Ngaio connection proposal

All submitters feedback

31 October – 21 November 2022

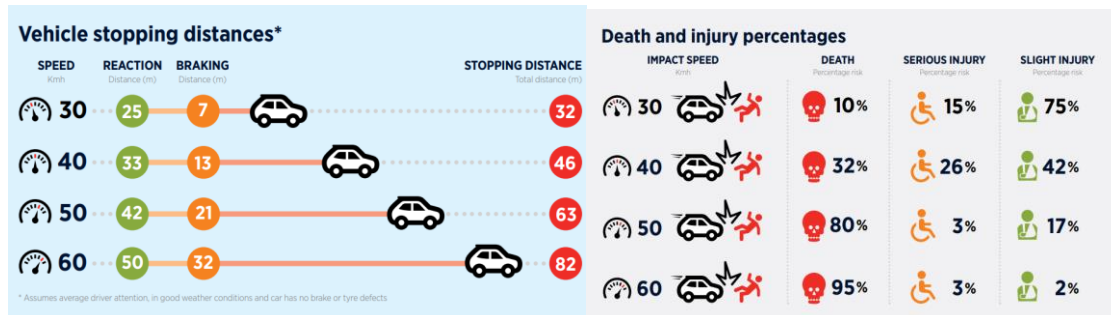
U-turns on Kenya Street. The proposal does not seem to have considered that by having parking on only one side of the road, it will mean vehicles travelling from the Ngaio end, will have to cross the road to find parking spaces. Drivers would have to either perform a U-turn or a three-point turn on Kenya St, or drive to the Kenya St/Ngaio Gorge Road intersection and turn into Trelissick Crescent and then back onto Kenya Street, to head north. Also, everyone parking on Kenya Streets west side but who want to head south will either have to use the corner of Kenya Street/Crofton Downs, by the crossing or the roundabout at Waikowhai St/Ottawa Road, or carry out a U-turn.

Performing a **U-turn in 50km./hr speed zone is dangerous**, and carrying out a U-turn or three-point turn will likely require vehicles using the cycle lane and then again in the opposite shared lane, potentially very dangerous and putting cyclists at risk.

Alternate Recommendation

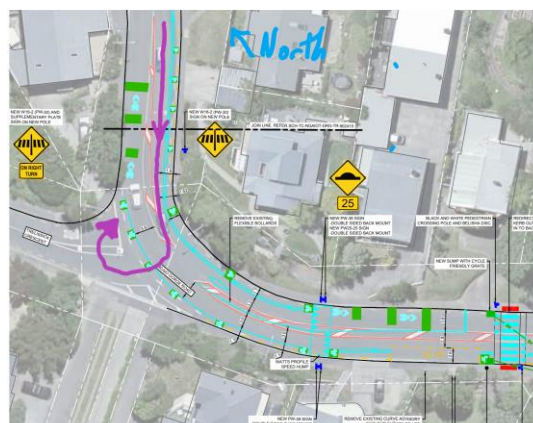
- 2.1 For cyclist safety at this intersection, the northbound cyclists be directed first down Trelissick Crescent, make a hook-turn and then take a left turn into Kenya St when clear.**

- 2.2 Install a roundabout at the Kenya Street/Ngaio Gorge Road/Trelissick Crescent intersection**

Alternate recommendation

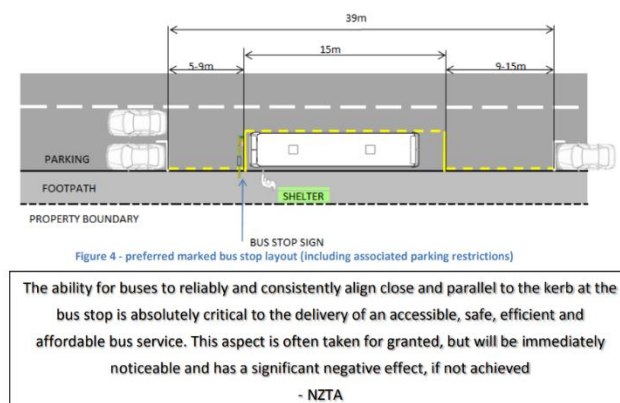
2.1 As per the proposal, remove the four carparks at 48 – 54 Kenya Street and

2.2 Do not remove the four unrestricted carparks at 48 – 54 Kenya Street.

- Extend the no stopping zone by removing one more carpark outside 52 Kenya Street
- Extend the no stopping zone by including the driveway at 50 Kenya Street.

The no stopping zone would be 33m metres long, not quite the NZTA preferred length, but more than twice as long than as present and it saves three of the necessary on-street carparks.

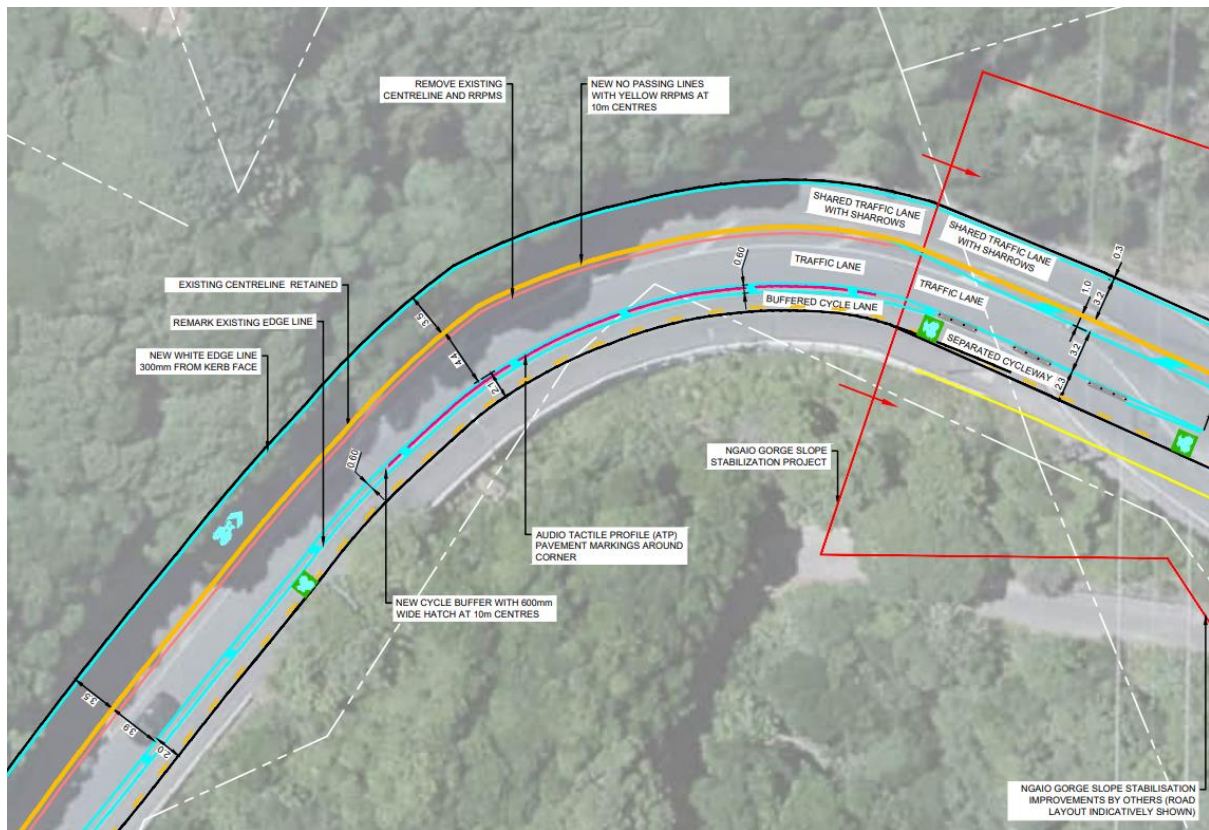
If the parking must stay then the speed limit MUST be reduced to 30kph. This will have a massive impact on the safety of mixing unprotected road users with general motor vehicle traffic. It will also have a minor impact on large commercial vehicles as the stretch most commonly used by them stops at around the oil tanks.

Lower speeds will also create a more pleasant environment for businesses as vehicles are not accelerating hard to get up to 50kph before slamming on the brakes.

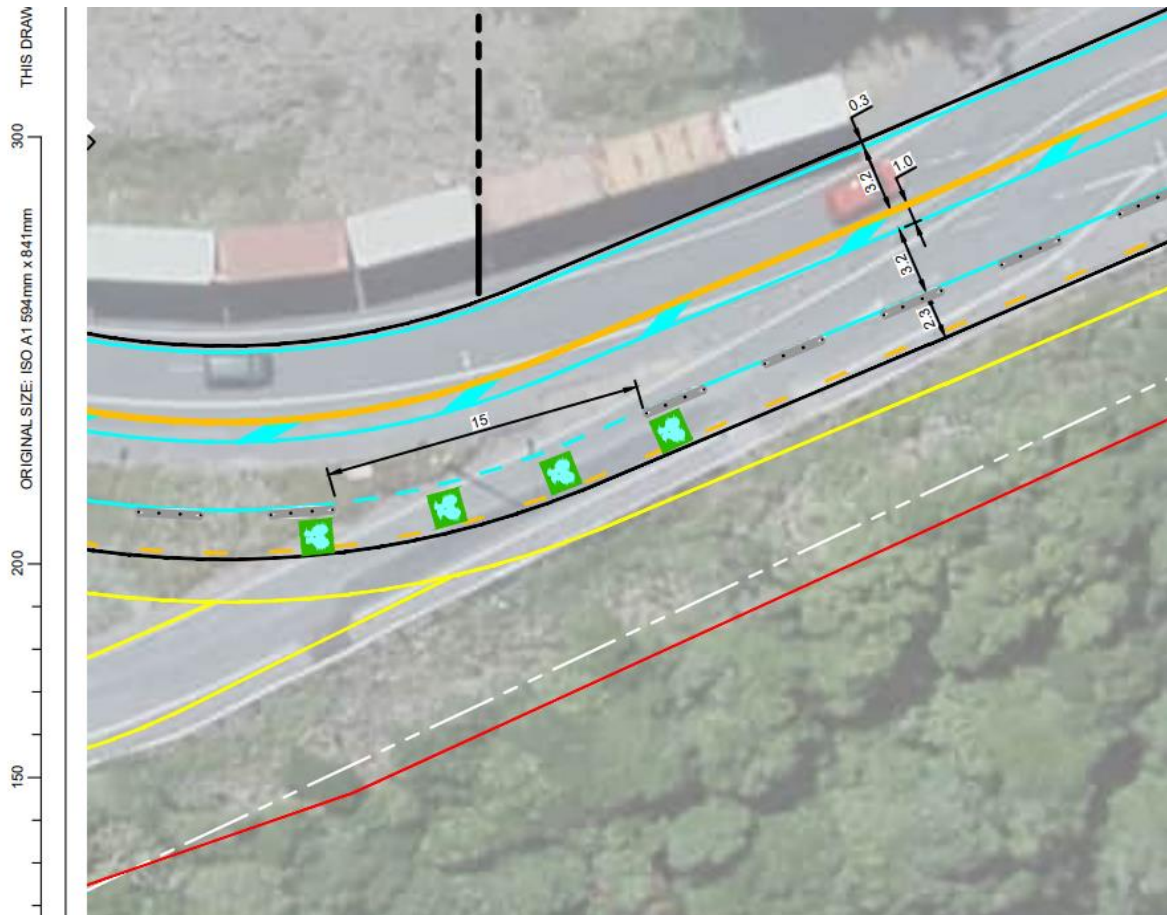
If micromobility users must share the lane with general motor vehicle traffic then the speed limit **MUST** be dropped to 30kph. This will encourage less confident cyclists to try it out, improve the safety of drivers exiting driveways, make cycling more pleasant, and reduce the roadway noise for nearby residential properties from vehicles accelerating hard.

The intersection into the proposed parking for Trelissick park does nothing to discourage drivers from taking it at anything less than 50kph. Micromobility users will be travelling much more slowly due to the uphill at this point. This lower speed will encourage drivers to try and rush to get in ahead.

Parts of the cycleway are so absurdly narrow as to not exist

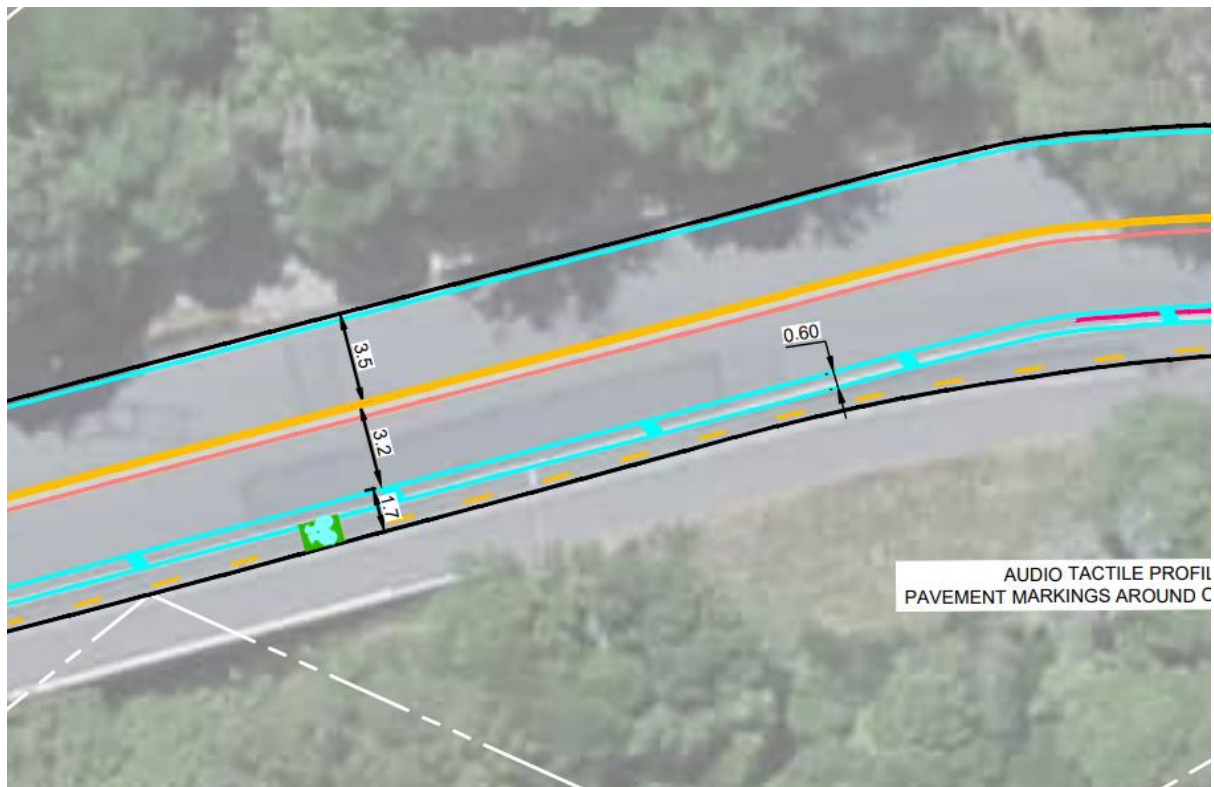
Parts of the proposed cycleway are so narrow that it becomes a sick joke that someone thought they would be safe and appropriate. The section proposed below has a nominal value of just 1.1m which seems reasonable at first glance. However that width includes the edge of the road and the gutter. Neither of which are safe for use. The edge of the road where the asphalt meets the gutter has a rough and carrying drop from one surface to the other. And the gutter is steeply angled to the gutter wall compared to the main roadway.

On top of that you will have traffic less than 60cm away zooming by at 50kph.
